Subject: Petition Response to Fuel Leak Case RO0000516, Hooshi's Auto Service,
1499 MacArthur Boulevard. Oakland, CA 94602

Alameda County Environmental Health (ACEH) has prepared this letter in response to the "Petition for Closure" dated May 6, 2005, prepared by Cambria Environmental Technology, Inc. (Cambria). Cambria the environmental consultant for Ms. Naomi Gatzke, requests case closure for the above referenced facility. Based on their review of the site background and conditions, Cambria believes that this site meets the Regional Water Quality Control Board - San Francisco Bay Region's (RWQCBs) definition of a "low-risk fuel site" as defined in their memorandum "*Interim Guidance on Required Cleanup at Low-Risk Fuel Sites*", dated January 5, 1996. Cambria has attached their "*Closure Request*," dated July 21, 2004 and their letter titled "*Clarifications Regarding Closure Request*," dated October 6, 2004, as supporting documentation for their closure petition.

TPHg and Benzene Concentration Trend Well MW-5

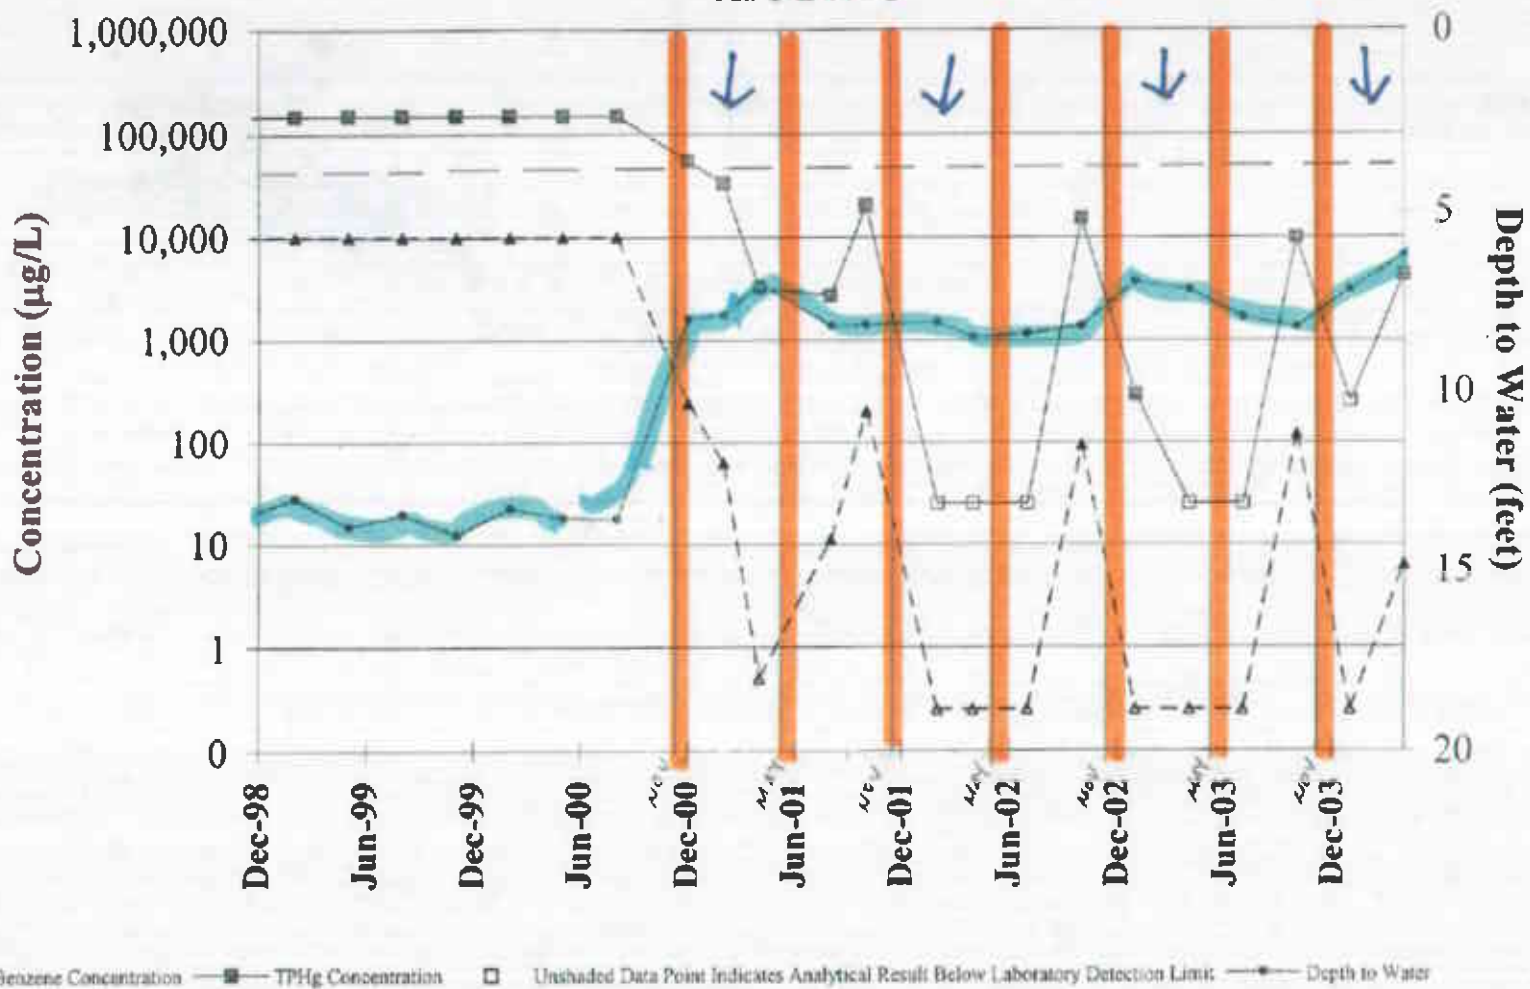
Cambria states that concentrations of TPHg and benzene will decrease to concentrations below their respective ESLs by 2010 based on simple trendlines drawn on graphs showing concentrations of TPHg and benzene over time in well MW-2. This analysis is invalid for the following reasons:

- Separate phase hydrocarbons (SPH) were consistently observed in well MW-2 prior to 2002. Several concentrations of TPHg that are included on the time concentration graph for well MW-2 exceed the expected normal range of solubility for gasoline. The intermittent incorporation of small volumes of SPH in groundwater samples has a significant effect on TPHg and benzene concentrations. It is not valid to project a linear trend over time using initial concentrations that exceed the solubility of gasoline. The decreases in concentrations over time are artifacts that reflect the incorporation of less SPH in the groundwater samples and clearly cannot be projected to continue at a linear rate over time.

- If only the data that represent dissolved phase concentrations are plotted (April 2002 to April 2004), a linear trendline drawn through the data shows an increasing trend.

- However, we disagree that linear extrapolations like the ones performed by Cambria are reliable predictors of future concentrations of dissolved contaminants. The primary reason for this is that Cambria has not described the mechanism whereby the concentrations will be attenuating over time. There are several reasons why the rates of chemical and/or biochemical reactions may decrease over time, with the result that plots of declining concentrations over time reach asymptotic levels.

Based on the above factors, Cambria's projection of concentration decreases over time based on TPHg and benzene data from well MW-2 is seriously flawed and invalid.

Exhibit 3 – Cambria groundwater elevation contours, 05/08/1998, 02//17/99, and 0/17/00

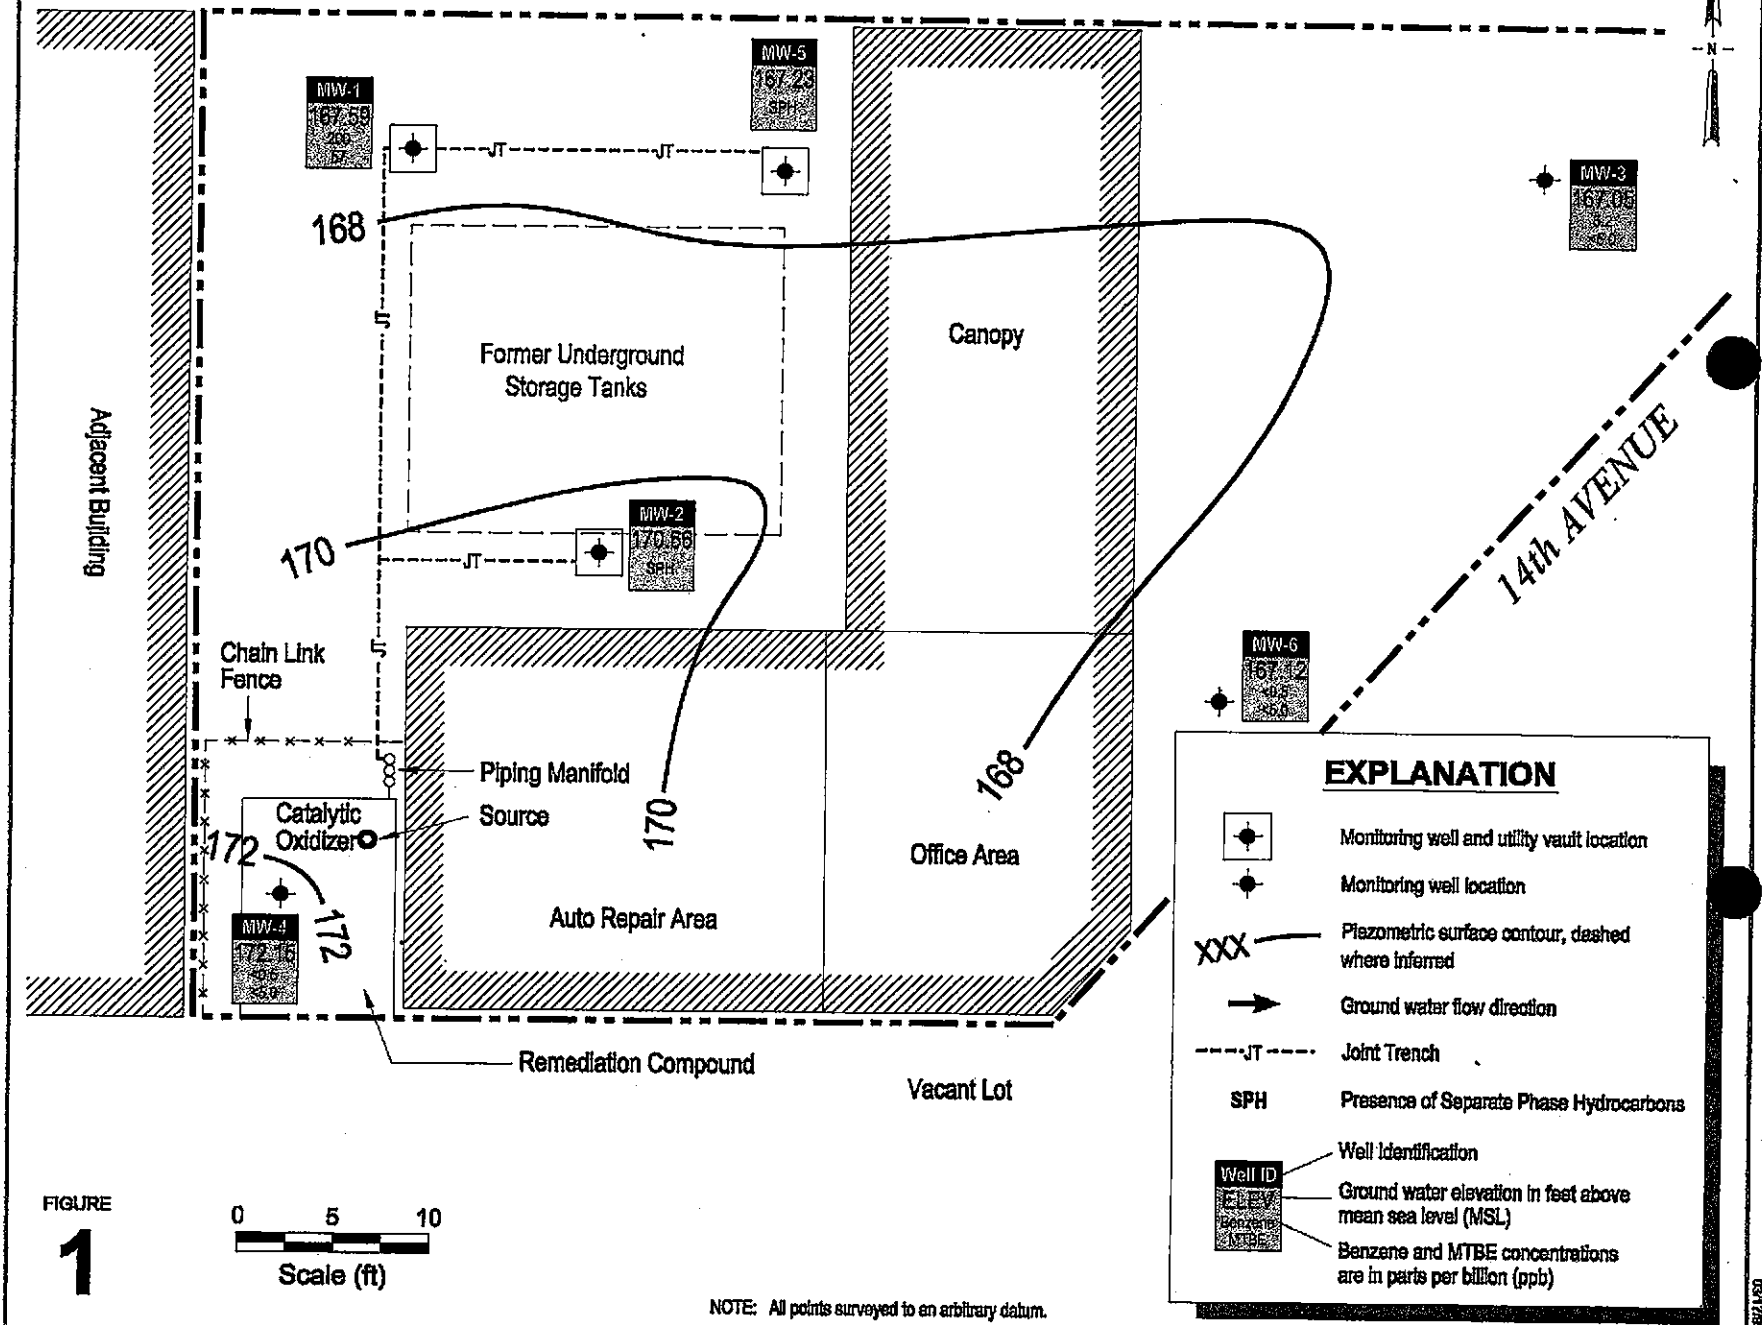
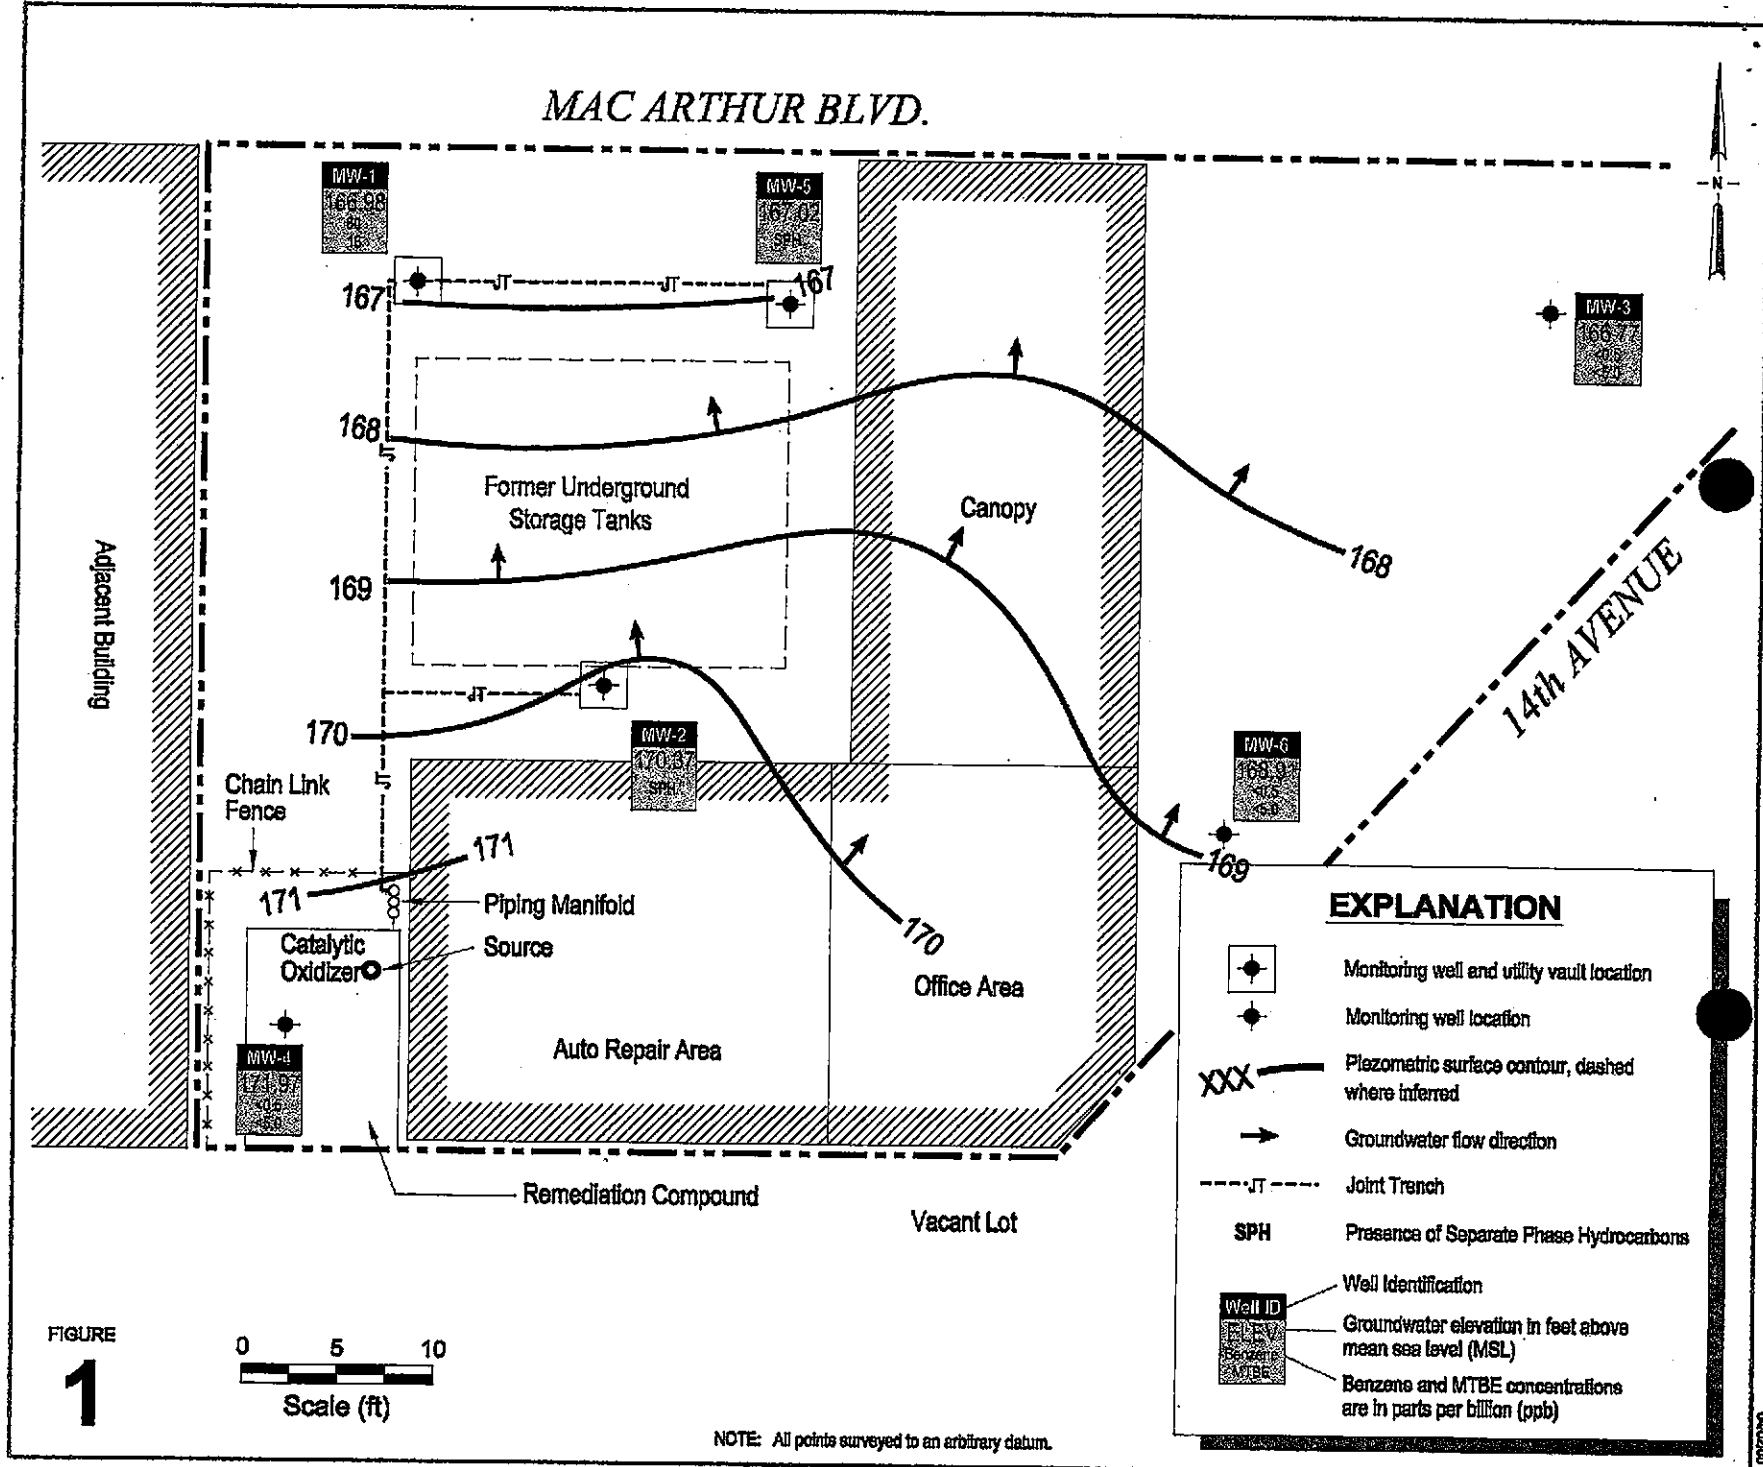
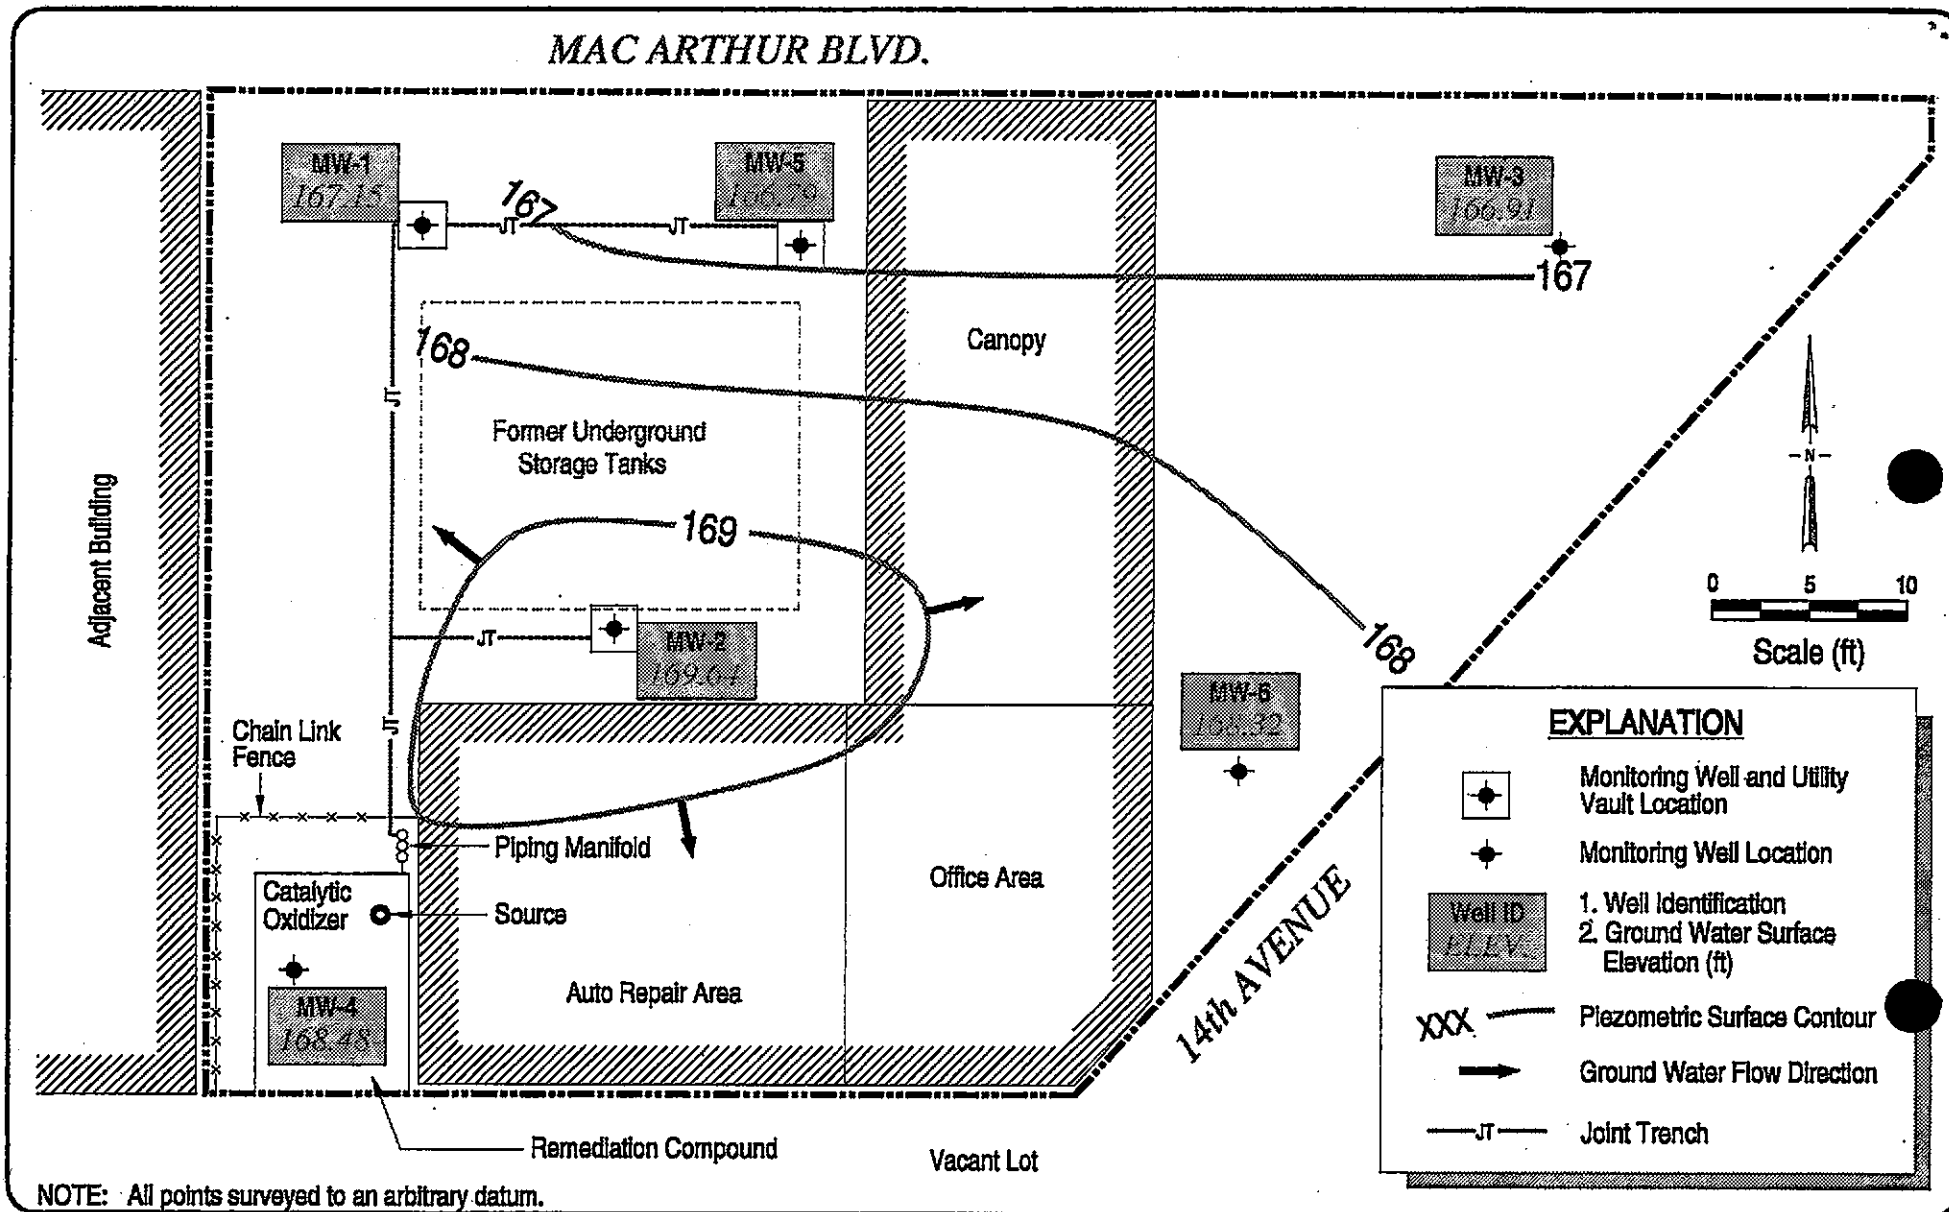
The site hydrogeologic conditions are also poorly defined. In particular, the groundwater flow field is not well characterized. The groundwater contour map included in the Closure Petition depicts equipotential lines drawn using water levels in site monitoring wells measured on April 2, 2004. The horizontal groundwater flow direction inferred from this figure is toward the southeast. Cambria states in their Petition that MW-4 monitors a dissolved plume downgradient from the source zone based on the flow directions inferred from the groundwater contour map. However, we have reviewed several other groundwater contour maps prepared using water level data on different dates (Exhibit 3) and horizontal groundwater flow directions implied by the equipotential lines in those maps suggest flow to the northeast. Some or most of the variability in the inferred horizontal groundwater flow direction could be attributed to hydraulic mounding in the center of the site. If there is mounding that is causing diverging flow, this

mounding can also cause downward vertical flow. This could be a mechanism whereby contaminants in or near the tank backfill could have been conveyed to depths greater than the total depth explored or monitored at the site. Cambria has not addressed this question, nor can they with the existing groundwater monitoring network since there are no well pairs or clusters installed at the site that could yield important information regarding the vertical distribution of dissolved contaminants or hydraulic head. There have been no hypotheses formulated to explain the mounding nor the causes of the (related?) erratic/variable apparent groundwater flow directions. That is a fundamental deficiency in the site characterization because an effective groundwater monitoring program cannot be developed until the site groundwater flow system is defined in three dimensions.
